# Waterside House, Uxbridge

## *Class AA Upward Extension Application*

**Report Title:** Class AA Upward Extension Application

TPM Studio have been asked on behalf of Permitted Developments Investments No. 7 Ltd to prepare and submit a statement in support of the Section 73 Application relating to the proposed redevelopment of Waterside House in Uxbridge.

## 1.1 Third Floor Layout

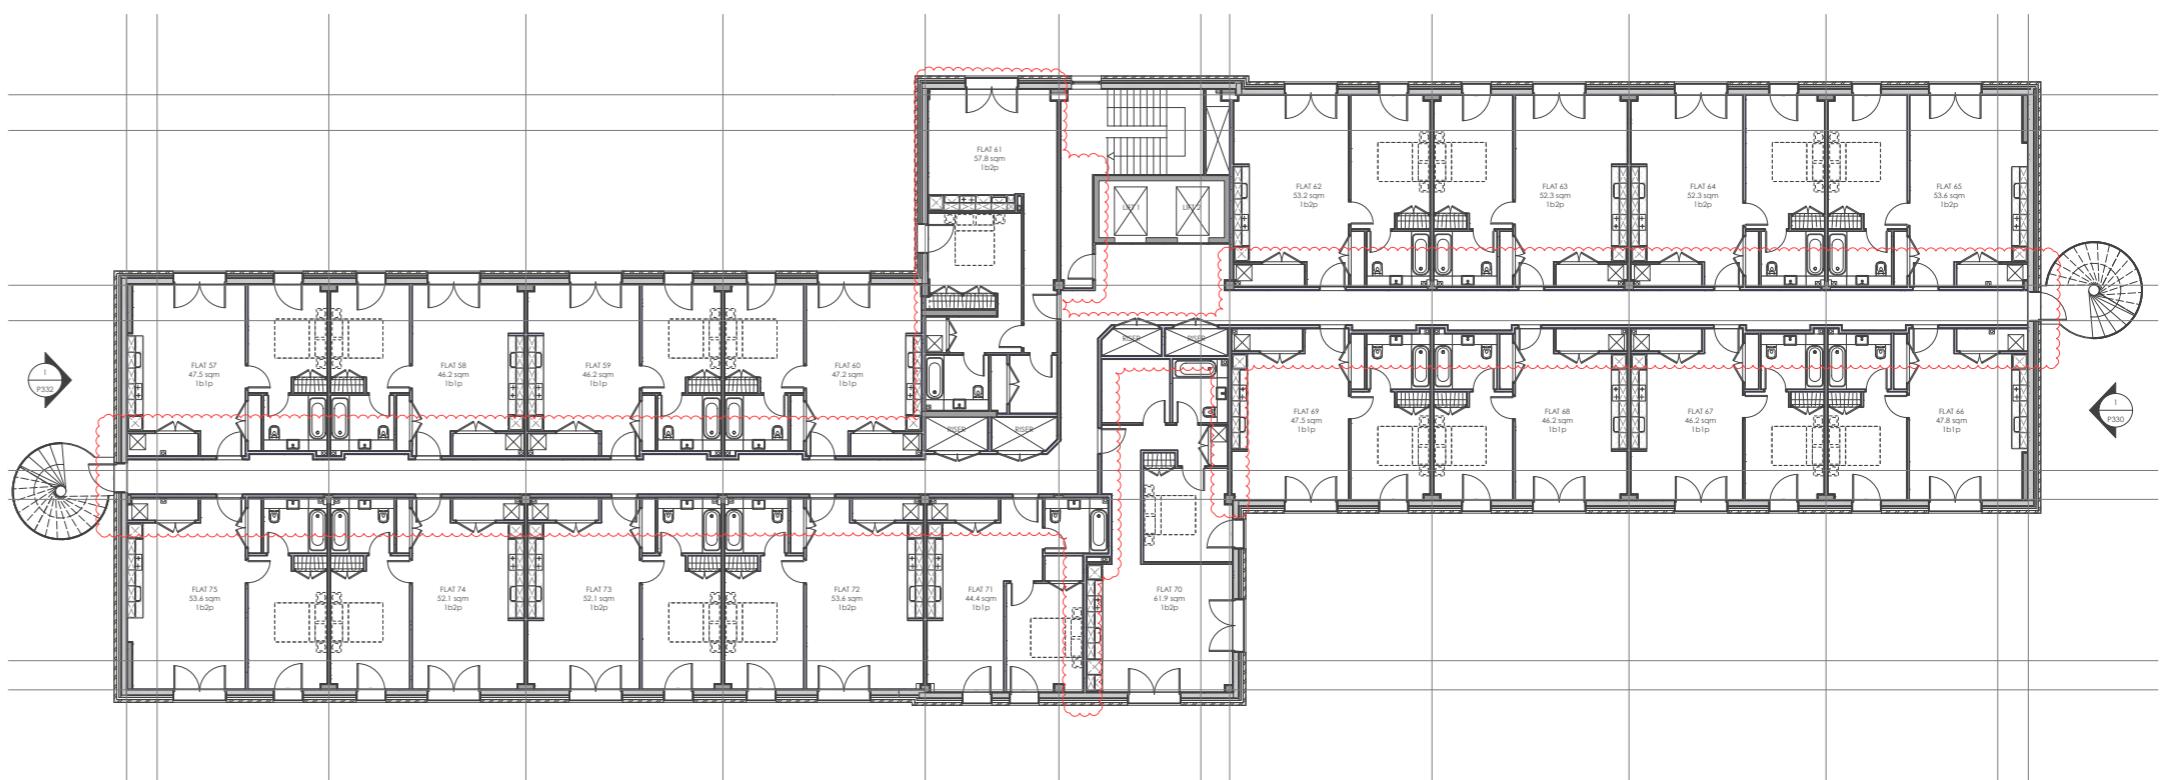
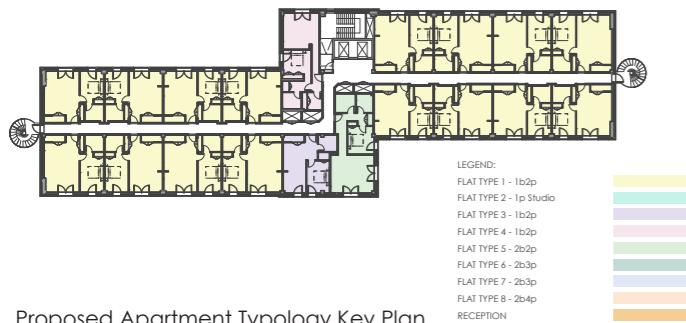
- The arrangement of apartments on the fourth floor is consistent with the consented scheme where the predominant changes occur along the internal wall of apartments where the width of the corridor has narrowed slightly to allow for generally 1200mm clear wall-to-wall, with passing spaces 1500mm in width. The naming conventions of the individual apartments is consistent with the NDSS and the previous application.

- Minor internal modifications of apartments to create improved, more open plan living accommodation, with better access to storage.
- Rationalised arrangement of bathrooms and coordination of services between the ground and fourth floors.

- Modification of Apartment 61 (left-hand side of the stair core) owing to the continuation of the structures from the floors below.
- Modification of risers from advise from the MEP consultant.

- Modification of the internal layout of apartment 70, following changes to the arrangement of the service risers.

## 1.2 Fourth Floor Layout

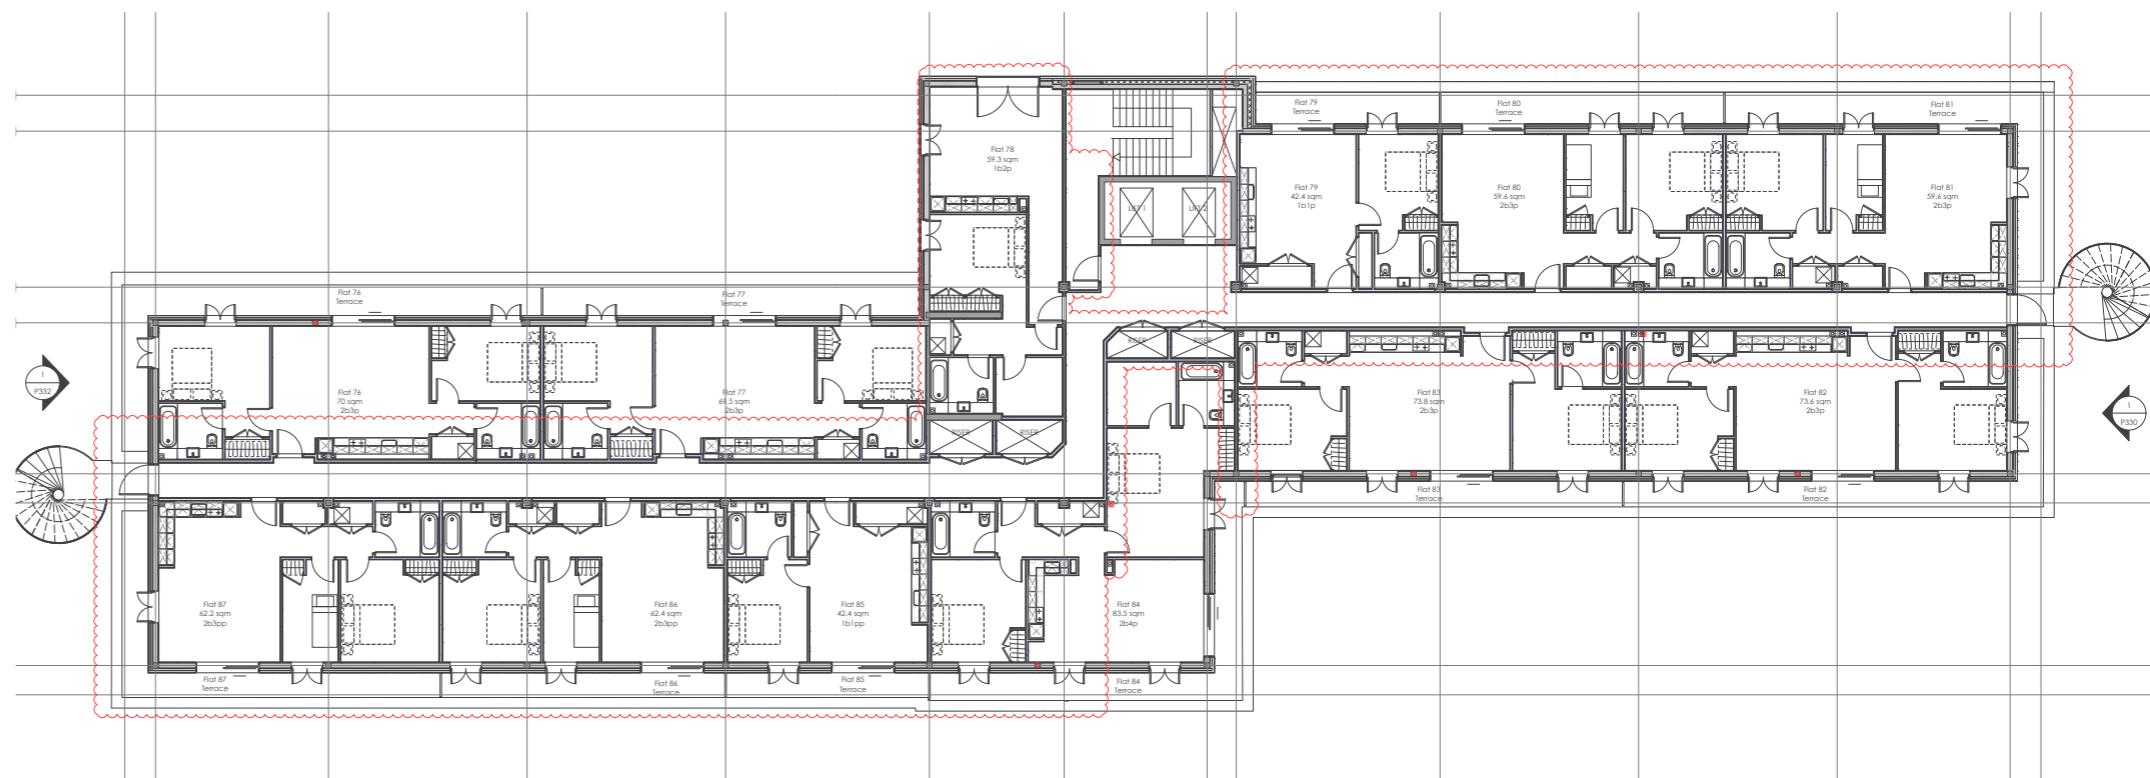
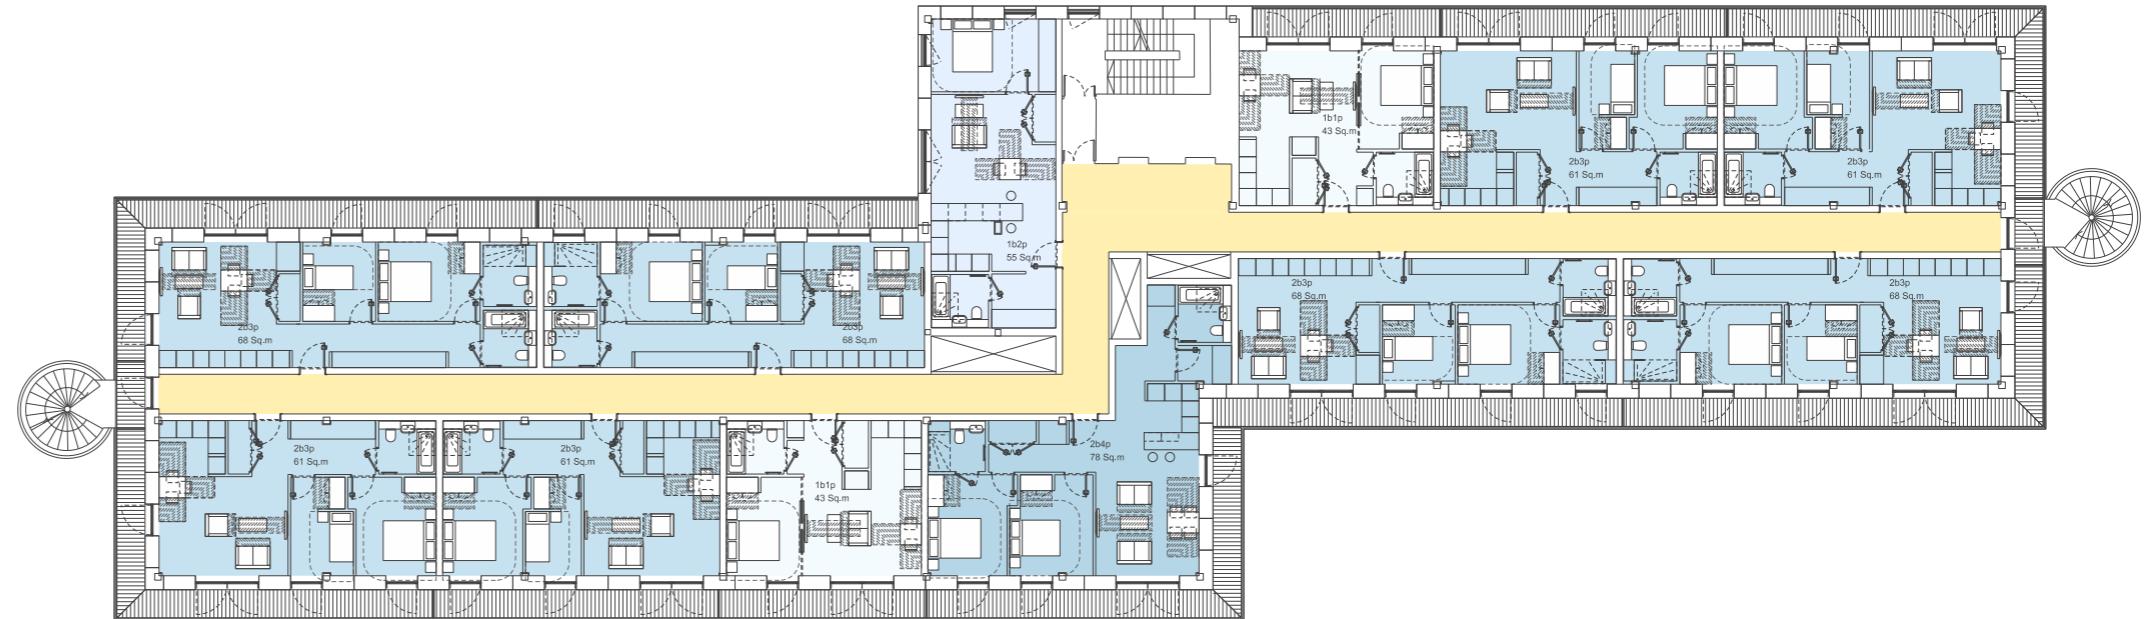
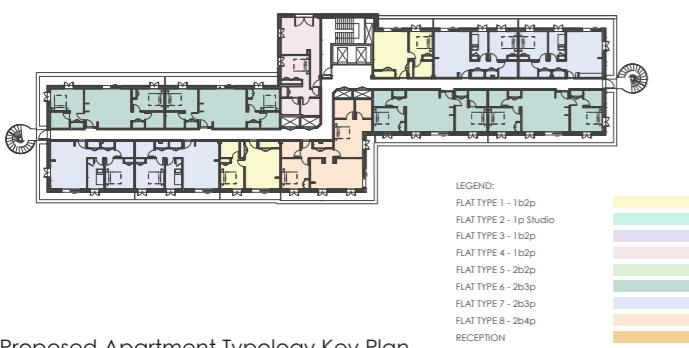
- Parapet increased in depth from what appears to be 100mm for buildability purposes.
- Changes occur along the internal wall of apartments where the width of the corridor has narrowed slightly to allow for generally 1200mm clear wall-to-wall, with passing spaces 1500mm in width. The naming conventions of the individual apartments is consistent with the NDSS and the previous application.

- Changes in the internal arrangement of the 2b3p apartments to the north side of the west wing and to the south side of the east wing. The primary drivers for changes included the alignment of services with the floors below, creating a more modern arrangement of bedrooms and bathrooms either side of the central living space.

- Modification of Apartment 78 (left-hand side of the stair core) owing to the continuation of the structures from the floors below.
- Revised riser positions and sizes following MEP advice.

- Changes in the arrangement of the consented fenestration, where once the depth of the proposed parapet has been included, sliding doors and smaller Juliet balcony doors are more appropriate to provide access onto the terrace.

## 2.4 Appearance & Window Arrangement - South Elev.

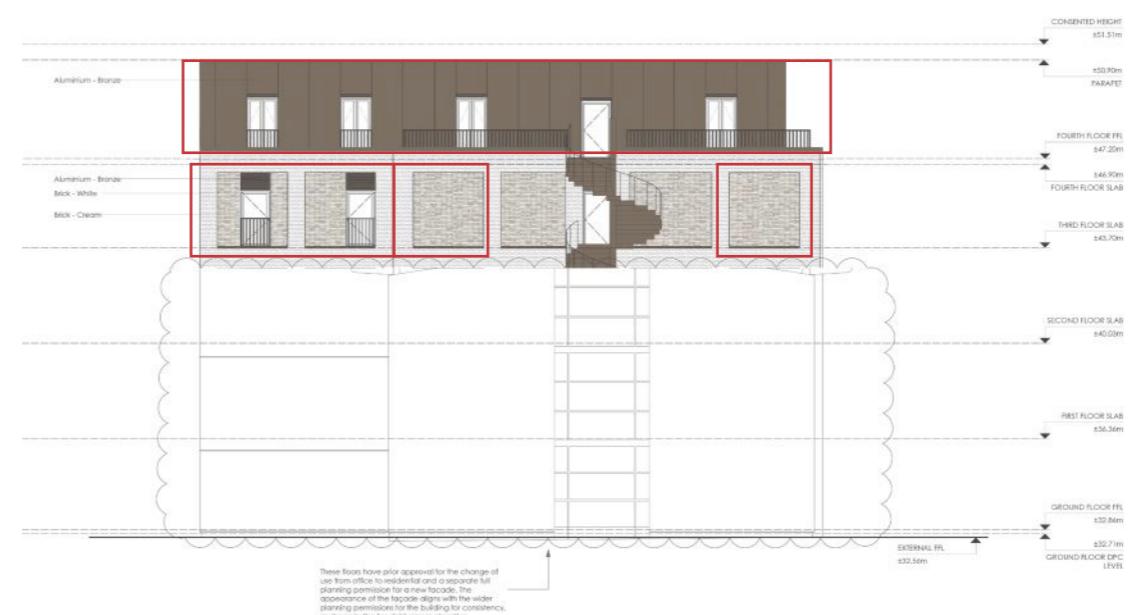
- As a result of the existing levels and structure, modifications to the heights of windows/ balcony doors have been made when compared with the consented scheme.

- These existing constraints result in a slight adjustment to the vertical and horizontal white brick grid with a slight variation in which the two outermost vertical brick piers becoming 4 bricks wide where all horizontals are now 11 bricks high with exception of the course between ground and first floor which is 9.

- The Consented Approach of achieving the contrast between the white and cream bricks is no longer provided by the "25mm wide metal profile" but by recessed cream bricks which exaggerate the impression of a punctured facade. The decision to approach this in a different manner has been informed by buildability issues this detail would present in addition to a lack of built examples. Moreover the detail, particularly at the head condition would have presented issues with maintenance where the cream bricks would have become stained being set within the same plane as the white bricks above.

- Highlighted adjacent and in red are the areas of the facade where the arrangement of windows has been modified to suite the replanning of internal apartments and the position of existing structures. To the fourth floor the unsuitable handrail detail as consented has been substituted for a parapet with a recessed handrail behind. In addition on this floor large balcony doors have been substituted for a sliding door, where the large single glazed doors are now juliet balcony doors owing to the reduced size of the terrace compared with the consented scheme.
